**STONY PLAIN REGION
GEOHAZARD RISK ASSESSMENT
SITE INSPECTION FORM**

SITE NUMBER AND NAME: NC 2 - Pavement Cracking	HIGHWAY AND KM: Hwy 22:30, km 3.64	PREVIOUS INSPECTION DATE: June 2, 2009	INSPECTION DATE: May 20, 2010
LEGAL DESCRIPTION: SE 11-49-7-W5M	NAD 83 COORDINATES: -60737 E, 5897694 N	RISK ASSESSMENT: PF: 10 CF: 4 TOTAL: 40

North Central (Stony Plain)
Geohazard Risk Management Plan
NC-2 Wiley West Park

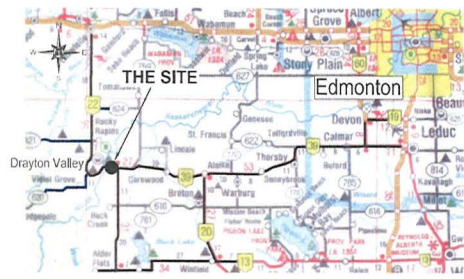
ITEM	CONDITION EXISTS		DESCRIPTION AND LOCATION	NOTICABLE CHANGE FROM LAST INSPECTION	
	YES	NO		YES	NO
Pavement Distress	X		Cracking present in eastbound lane. Dip in pavement observed Continued movement north of Hwy 22	X	
Slope Movement	X				X
Erosion		X			
Seepage		X			
Culvert Distress		X

- Magnitude of crack in pavement has increased from last year. Dip in pavement has developed and is suspected to be in relation to embankment movement. Continued movement could greater deflection in the pavement surface.
- Sealant appears to have failed which may contribute to cracking of the pavement.
- Instrumentation observed near the creek, north of Hwy 22. Suspected to have been installed as part of proposed highway realignment.
- Recent tree clearing for access road in area, possible conducted as part of geotechnical assessment for proposed highway realignment.

- Pavement cracks which formed in 2004 should be sealed regularly to minimize infiltration.
- The deflection in the pavement that has developed should be monitored and may require patching if dip increases in size.
